MAINE DEPARTMENT OF HUMAN SERVICES APPLICATION FOR PRIVATE SEWAGE DISPOSAL PERMIT		This is NOT a permit; this form when completed must be presented to the Local Plumbing Inspector to obtain a permit.		Page 1 of 2
Town Augusta	Street, Road, etc. Burns Road If on water body, give name	Plumbing Permit No. 48503	Date of Plumbing Permit 10-30-81	
Owner of property Lucille Brunelle	Owner's address Burns Road	Size of lot 20,000	<input checked="" type="checkbox"/> Sq. feet <input type="checkbox"/> Acres	
Name & type of establishment if other than private home Home	270 gpd	Is lot Zoned? <input checked="" type="checkbox"/> Yes <input type="checkbox"/> No	Type of Zoning N/A	Shoreland Resource Protection
Name of applicant Owner's agent Lucille Brunelle	Applicant's address Street, Box, etc. Burns Road Augusta, Me.	Tel. No. 622-9229	If you plan to use a previous subdivision approval in lieu of site investigation, please submit one of the following: <input type="checkbox"/> Deed restriction re. private sewage disposal <input type="checkbox"/> Copy of the subdivision soil report <input type="checkbox"/> Soils report from a State Agency

Replacement System Variance Request

SITE PLAN For Lucille Br

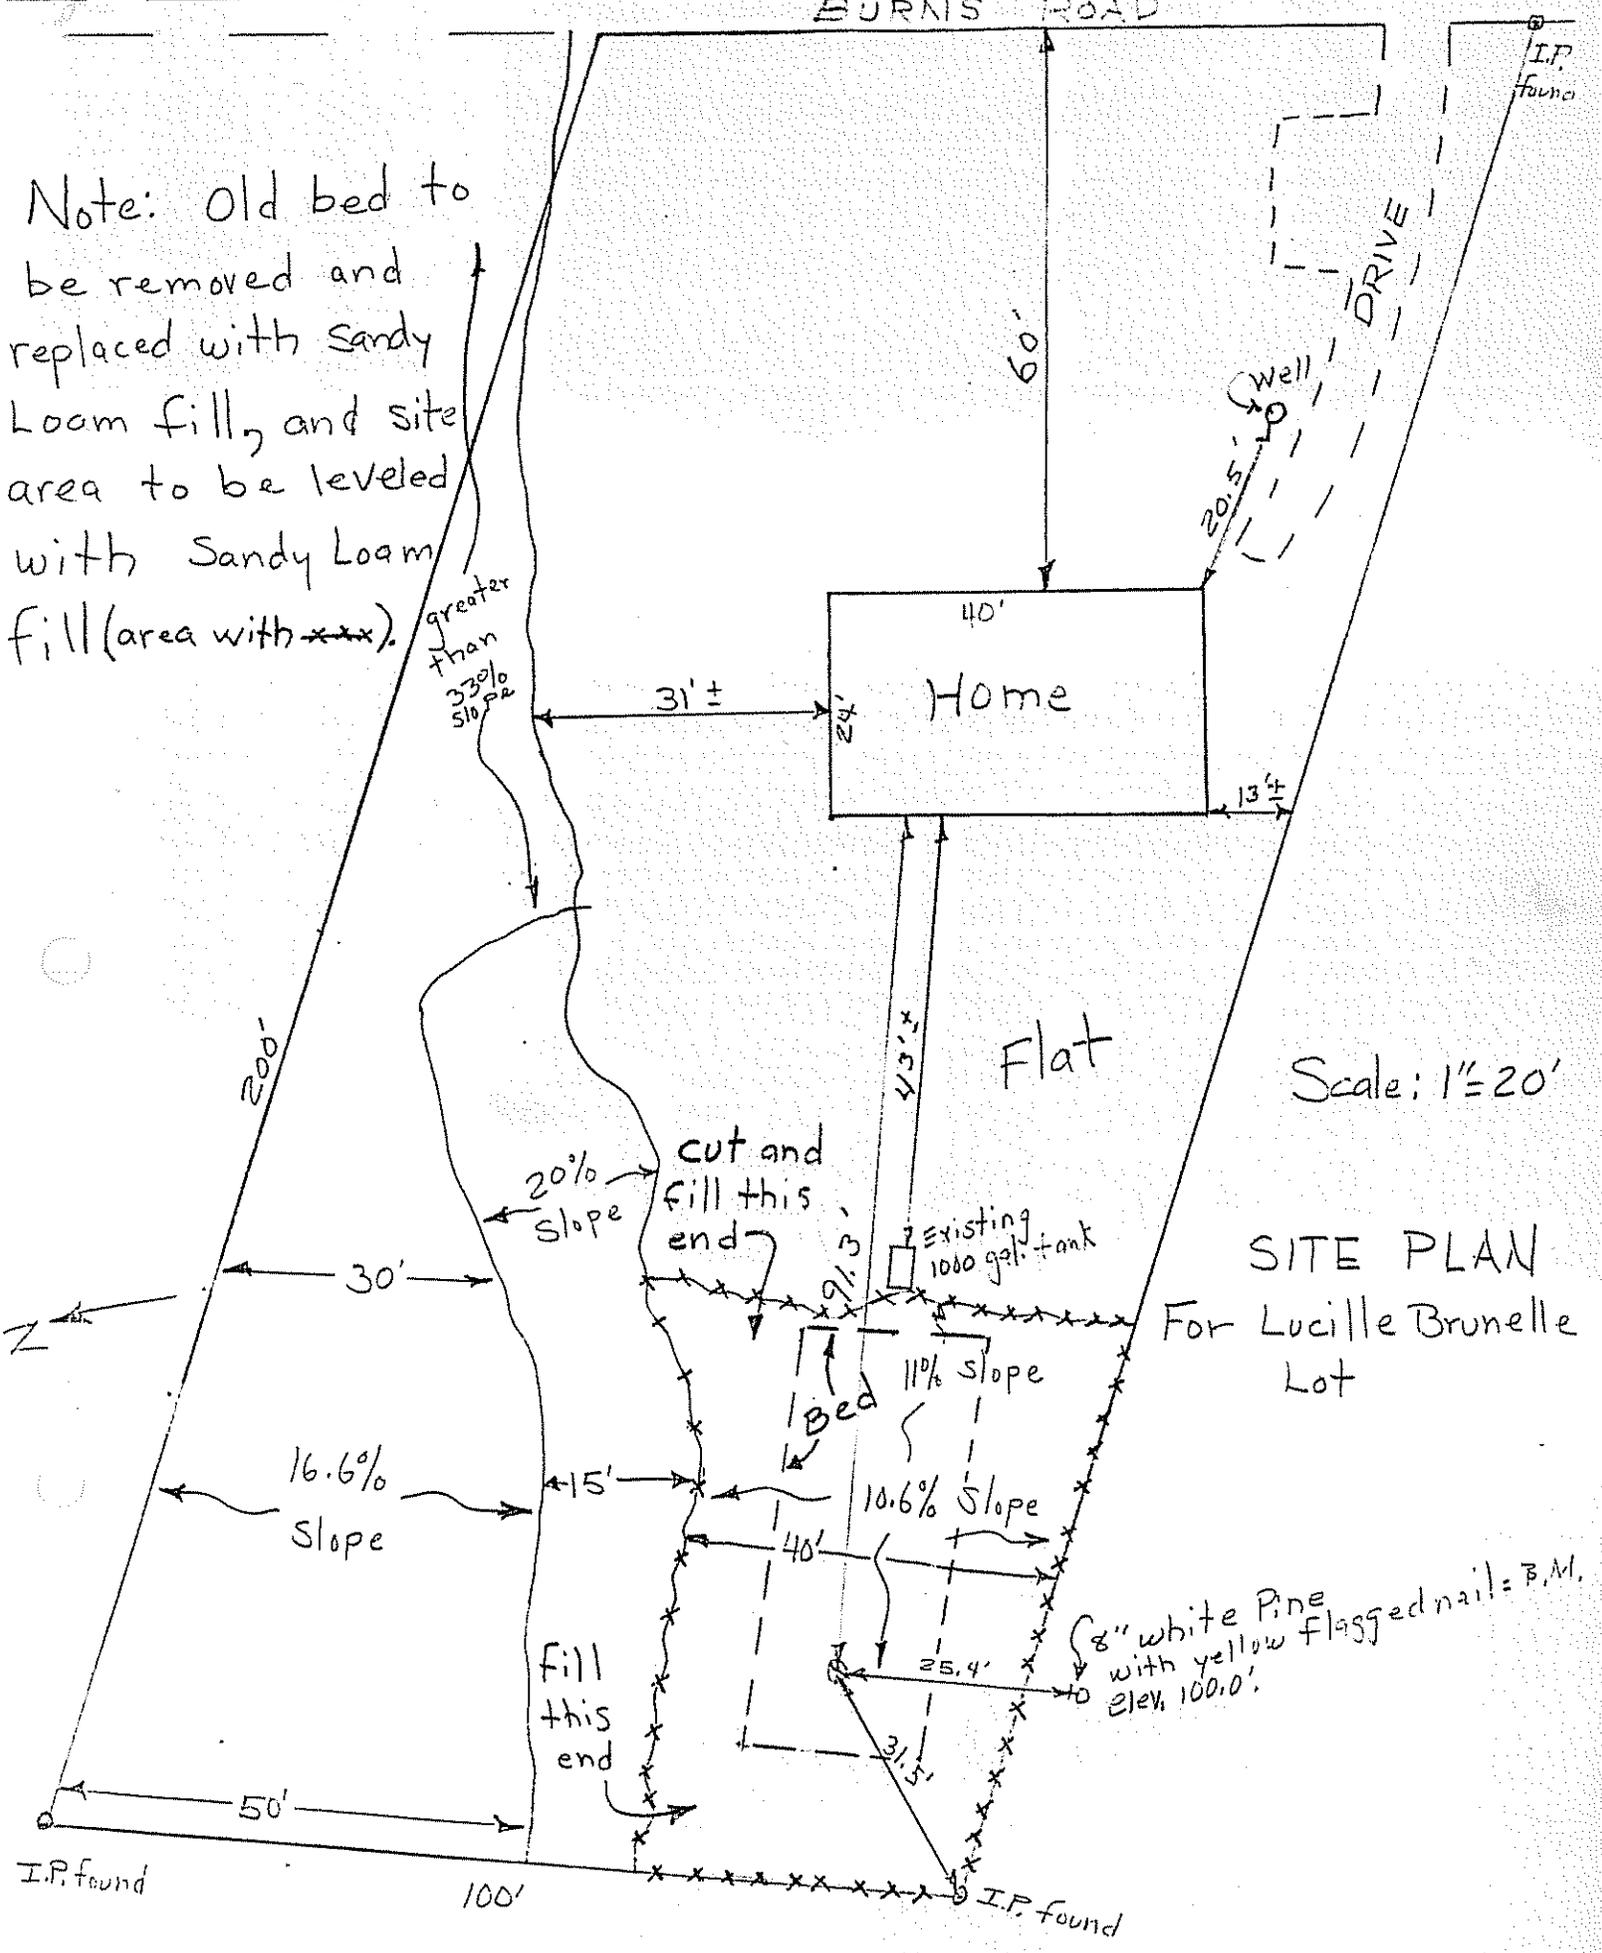
Need diversion between bed and property line.
